## **Attachment 1 - Responsiveness Summary**

**RESPONSIVENESS SUMMARY  
SUMMIT NATIONAL SITE  
DEERFIELD, OHIO**

FIGURE 1

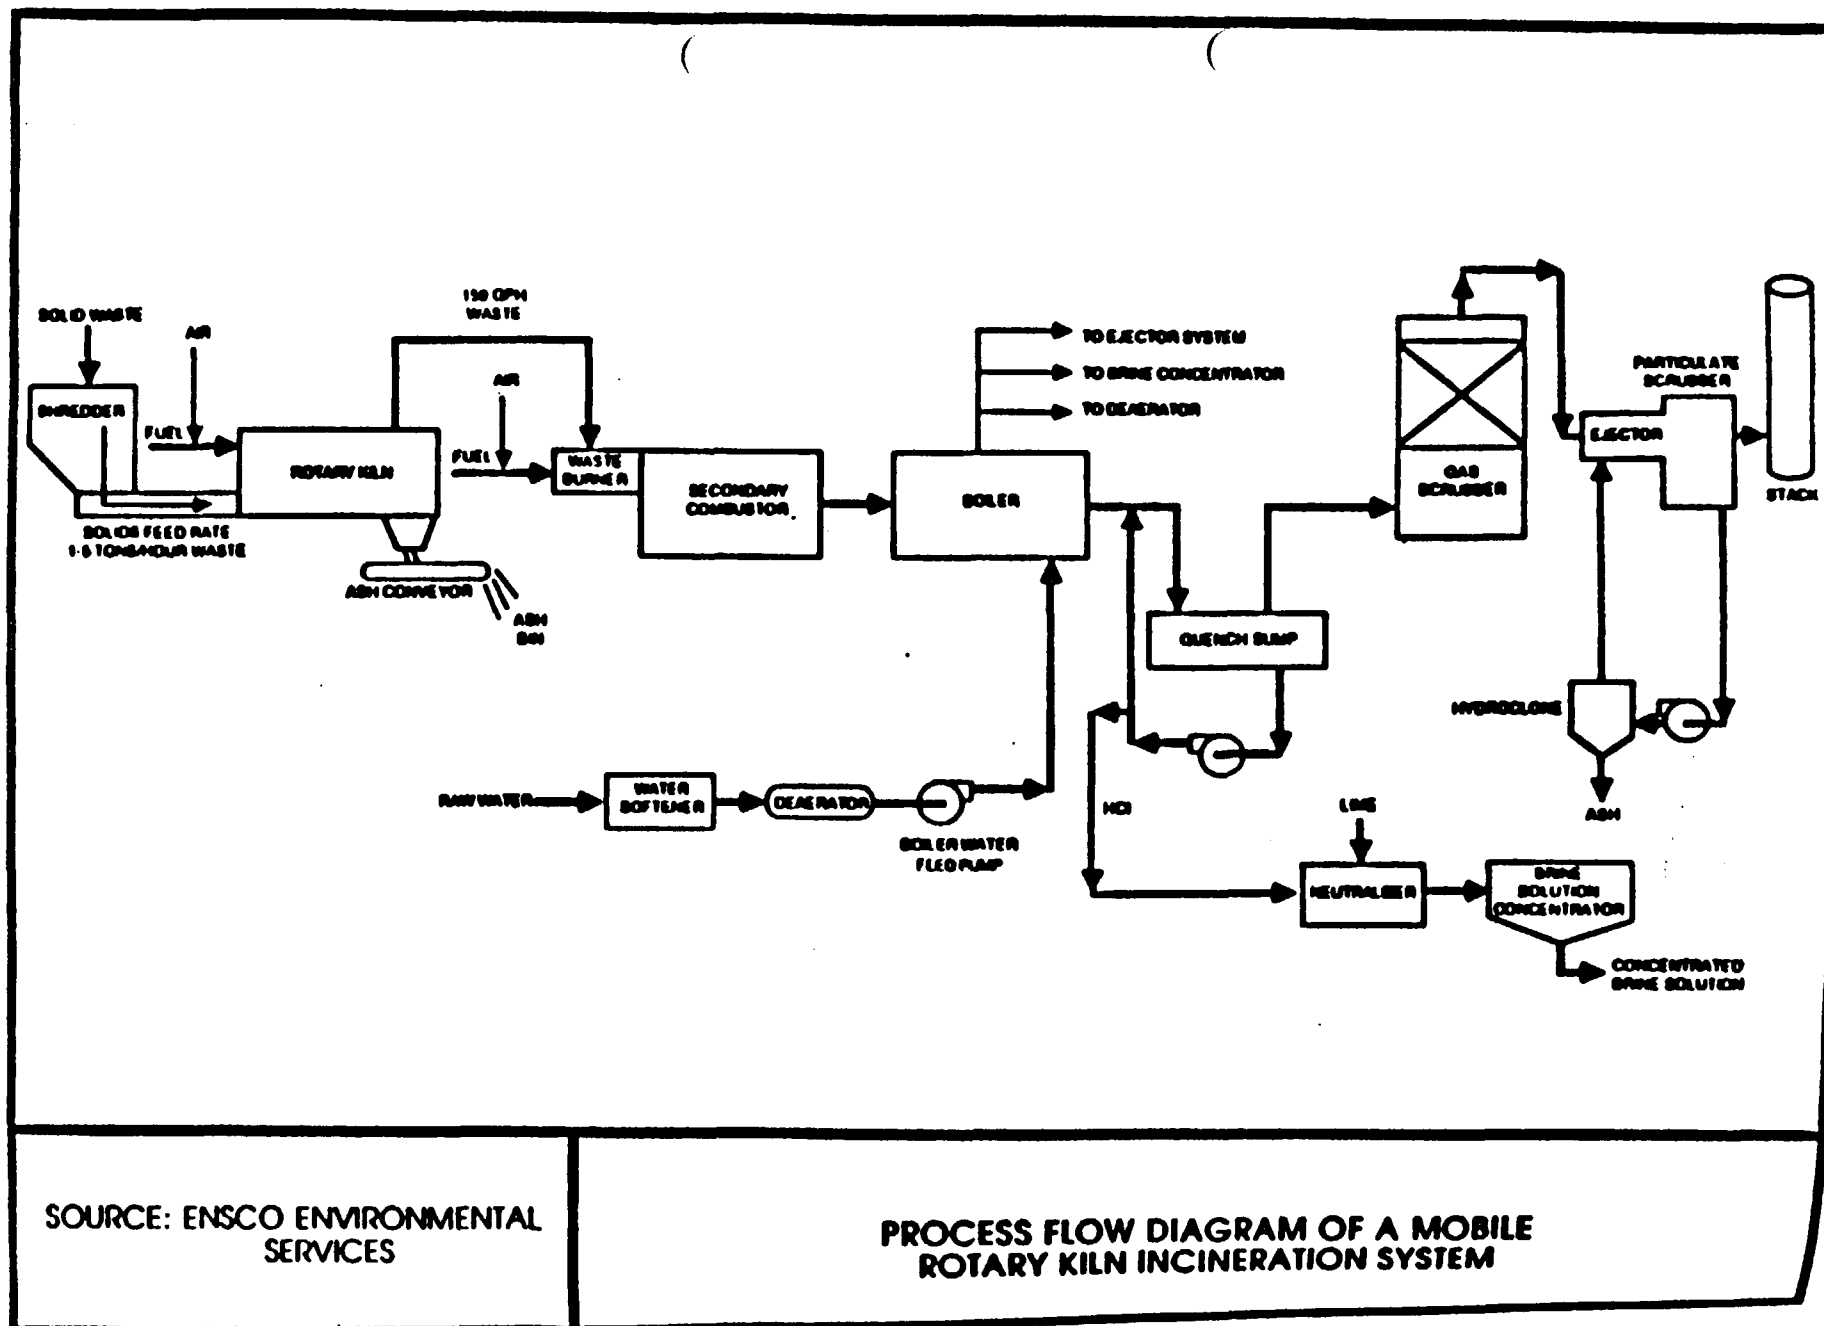
An environmental group questioned if the proposed incinerator had any emissions control.

The on-site incinerator will be designed so that all applicable requirements, State and Federal regulations listed on Table 6-1 of the Feasibility Study (FS) and Table 4 of the Record of Decision will be met (i.e., Resource Conservation and Recovery Act (RCRA), Clean Air Act). The emission control system for an incinerator typically consists of a gas scrubber system and a particulates scrubber system as shown on the attached schematic (Figure 1). Exhaust gases from the kiln enter a secondary chamber afterburner operating at temperatures between 1400°F and 2400°F to complete oxidation of the combustible waste. Prior to release to the atmosphere, exhaust gases from the afterburner pass through air pollution control units for particulate and acid gas removal. All of the existing mobile rotary kiln systems use a scrubber as part of their air pollution control system. General operating standards for incinerators treating hazardous waste are outlined by federal regulations contained in 40 CFR 265, Subpart O of RCRA (FIGURE 1).

FIGURE 3

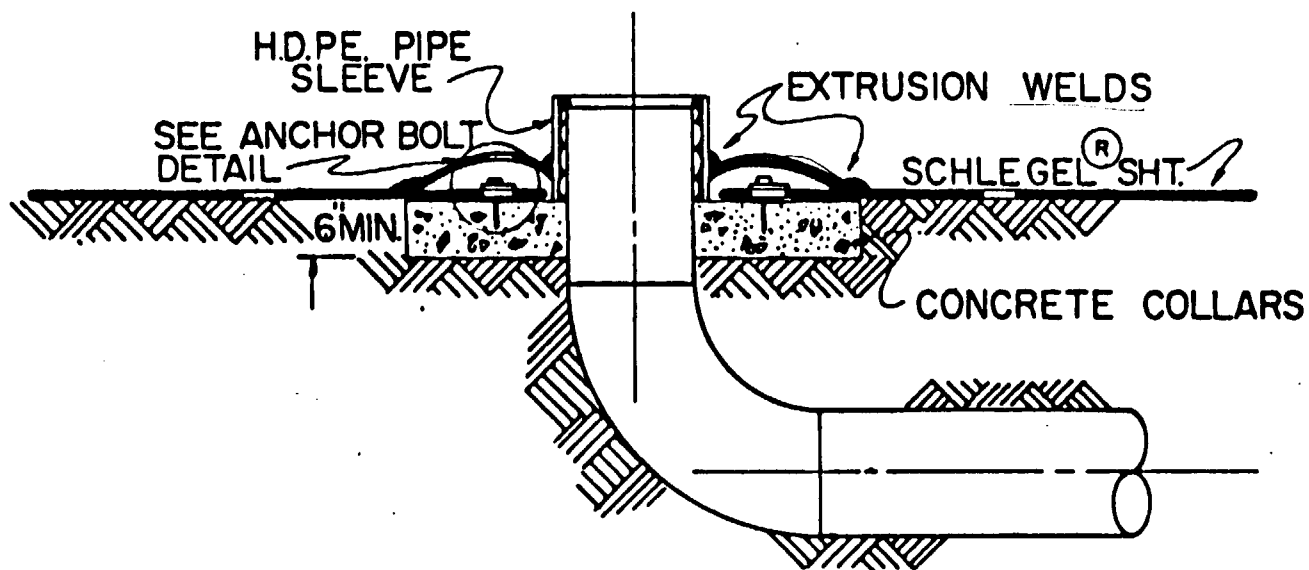
The commenter believes that the construction of extraction wells and a liner will not provide for a sound integratable structure, considering the large number of wells to be utilized.

The installation of a double synthetic liner and leachate extraction system around the pre-installed groundwater extraction wells does not impact the integrity of the liner. Gundle Lining Construction Corporation and Schlegel, two of the largest liner contractors, have provided construction details that illustrate adequate seals at a point where extraction wells and liners meet (see attached Figures 3, 4, and 5.). This type of liner has been constructed and proven to be a reliable technology in various construction applications. The design effort will try to minimize the number of wells used while maintaining the effectiveness of the groundwater treatment system, based on the additional hydrogeologic characterization, as noted previously.
